DEVELOPMENT NO.:	25024778
APPLICANT:	Adelaide Development Corporation
AGENDA ITEM NO:	3.2
ADDRESS:	42 Melbourne Street, North Adelaide SA 5006
NATURE OF DEVELOPMENT:	Construct five level mixed-use building comprising shop, lobby and ancillary carparking at ground, upper level dwellings and swimming pools with associated safety features
ZONING INFORMATION:	<p>Zones:</p> <ul style="list-style-type: none"> • City Main Street <p>Subzones:</p> <ul style="list-style-type: none"> • City High Street <p>Overlays:</p> <ul style="list-style-type: none"> • Airport Building Heights (Regulated) • Affordable Housing • Design • Heritage Adjacency • Hazards (Flooding - Evidence Required) • Noise and Air Emissions • Prescribed Wells Area • Regulated and Significant Tree • Traffic Generating Development <p>Technical Numeric Variations (TNVs):</p> <ul style="list-style-type: none"> • Maximum Building Height – 14 metres and 4 levels

LODGEMENT DATE:	28 August 2025
RELEVANT AUTHORITY:	City of Adelaide Council Assessment Panel
PLANNING & DESIGN CODE VERSION:	Version 2025.15 – 14 August 2025
CATEGORY OF DEVELOPMENT:	Code Assessed - Performance Assessed
NOTIFICATION:	Yes
RECOMMENDING OFFICER:	PC
REFERRALS

Figure 8.5.1 – 45-degree plane diagram

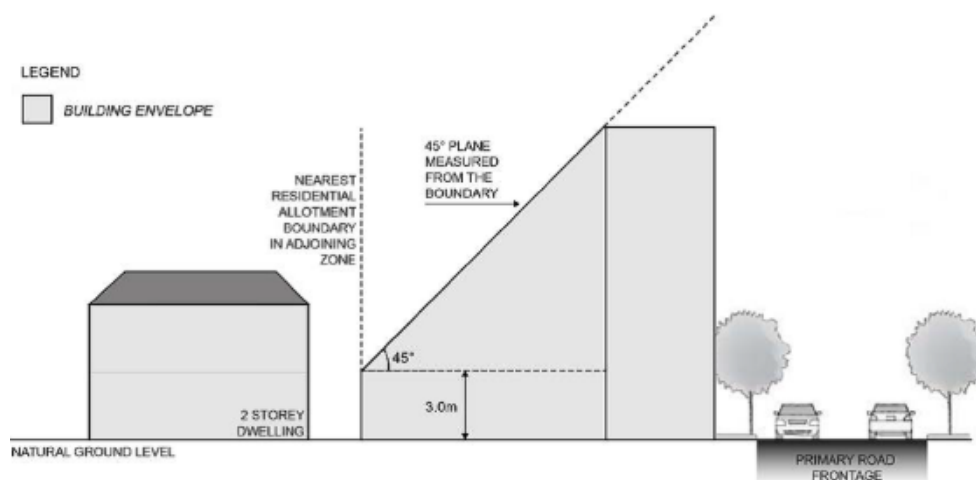
To mitigate visual impacts of building massing on residential development within the neighbouring City Living Zone to the north, DPF 3.1 seeks buildings constructed within a building envelope provided by a 45-degree plane measured from a height of three metres above natural ground level at the boundary of any allotment used for residential purposes in the City Living Zone as shown in Figure 8.5.1.

Figure 8.5.2 – comparison of proposal to 45-degree plane requirement

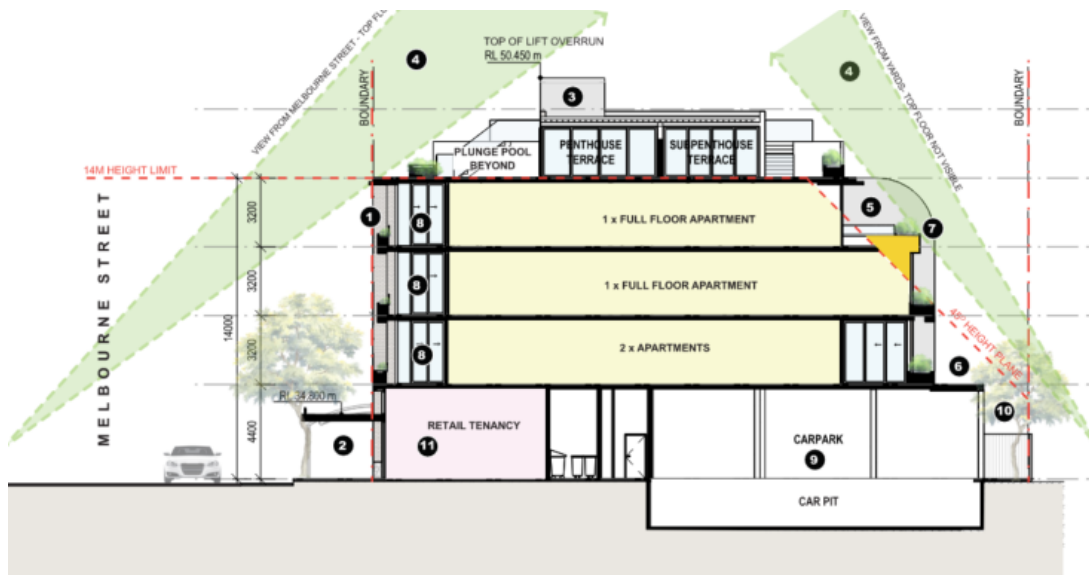
The proposal largely achieves the relevant /DPF provisions, except for relatively minor encroachments indicated in Figure 8.5.2.

The extent of built form outside of the 45-degree building envelope includes balconies and planters. Whilst there is a portion of the building that does not meet the 45-degree plane, most of the built form does sit within the envelope and importantly the floor area located on the level above the maximum height is within the envelope.
